MEMORANDUM

Douglas Chapman, PE

McGill Associates, PA

321 North Sewer Service

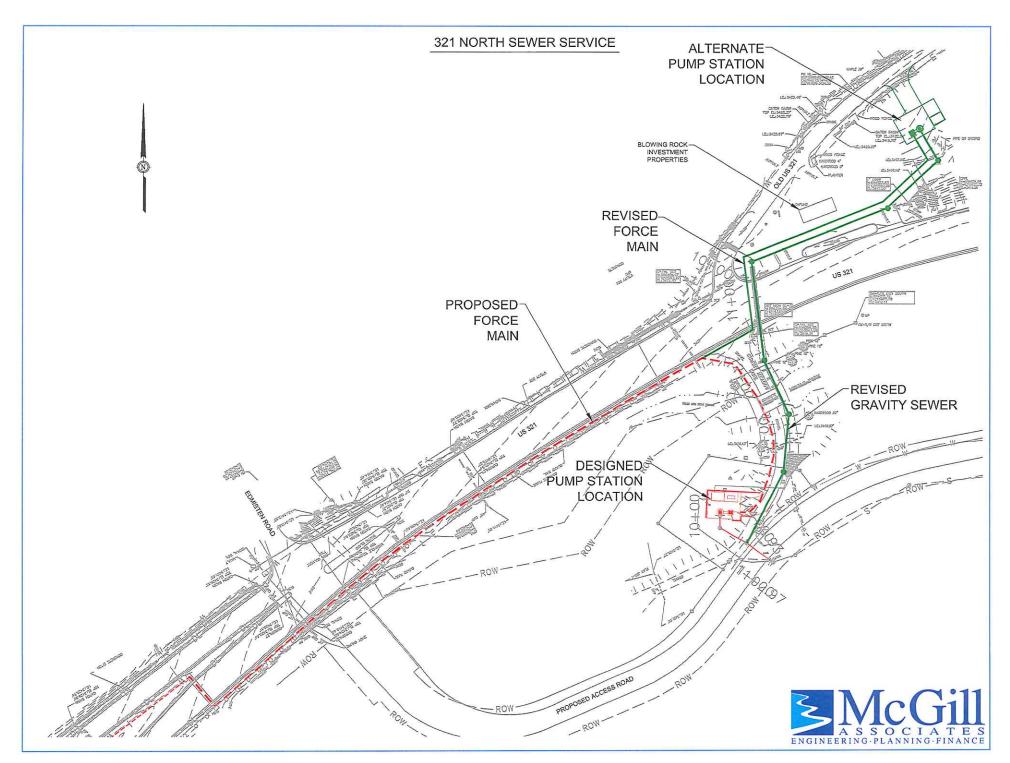
Blowing Rock has received several inquiries regarding sewer service along US 321 north of Town on the west side of the highway corridor. Upon considering these requests, we have evaluated connection to the sewer pump station being planned on the east side of US 321, north of Edmisten Road, as part of the post acute care facility (PACF) sewer service. At its current location, the new pump station will primarily serve the PACF, and any other ancillary facilities located on the same property. Due to the physical constraints of the river and surrounding topography, another pumping station would be required to serve properties on the opposite side of US 321. Upon further research, it has been discovered that gravity sewer can be extended from the PACF property, over the river, and under US 321 to the west side of the highway. By constructing such a gravity sewer line, and constructing the pump station on the west side of the road, more properties can be served as future needs arise.

Relocation of the pump station will require several elements that will increase the overall project budget. First, will be redesign of the pump station and related line work changes. Next will be the added cost to extended gravity sewer across the box culvert and under US 321 to the site. The final change is the additional force main needed to reach the pump station site. The estimated cost for this project change is \$186,000. As discussed, these additional costs could be funded through utility fund balance. Please find attached a map showing the original location of the PACF pump station, the newly proposed location, and the piping changes required.
